DATE: 9-29-17

APPLIES TO: This service bulletin applies to certain Spartan Emergency Response Tractor Drawn Aerial Fire Apparatus built by Spartan Motors USA, Inc. between November 2004 and December 2016

CONDITION: Loose or missing suspension fasteners / cracked suspension sub-structure

CORRECTION: Addition of reinforcing plate and increase fastener size

FIG. 13-2

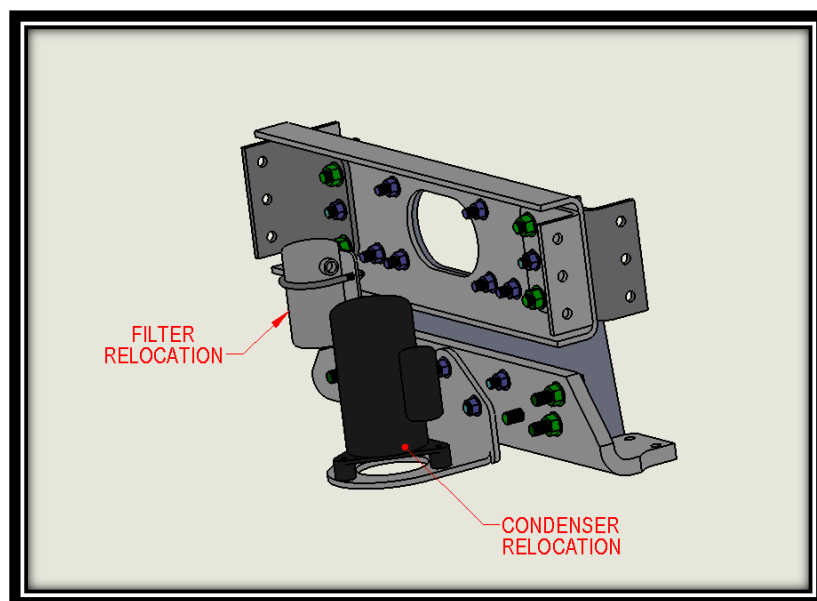
25. If equipped remount AC filter and condenser as shown below. Refer to FIG. 13-2.
